Denial of a Certificate of Appropriateness – 322 N. 8th Street

Historical Architectural Review Board COA Final Review Sheet

Address: 322 N. 8th Street

Proposal: Construct rear garage

**N. Lumber Street side of proposed garage per manufacturer website.
(Applicant)**

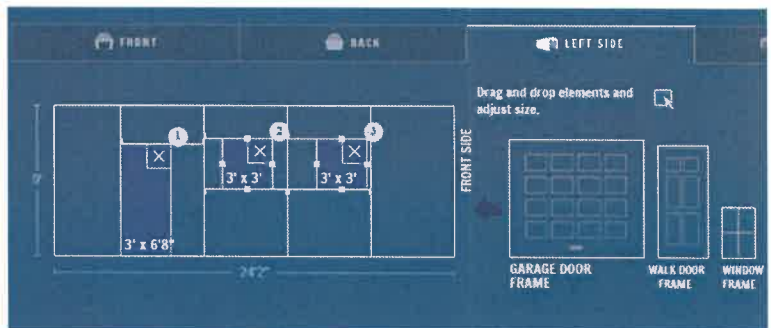
While the application lacks a site plan and details on the windows and doors, the general materials of the proposed garage are not appropriate for the district and do not comply with Guideline 5.2.10. More appropriate materials, such as brick or wood, should be considered for the structural elements and cladding, as noted in Guideline 5.2.9. Windows and doors should be wood or aluminum clad wood. The general panel configuration of the garage door and pedestrian door are acceptable. The windows should be one-over-one double-hung sash windows to more closely relate to the proportions of the main building, as recommended in Guideline 5.2.8.

The general size, scale, and massing of the building satisfies the guidelines, since the proposed structure would be subordinate to the main building. A site plan should confirm that the building would be constructed to the rear property line with no setback to satisfy Guideline 5.2.7.

Denial, pursuant to Chapter 5, Section 5.2 New Accessory Buildings, with the comment that more appropriate materials and proportions should be considered.
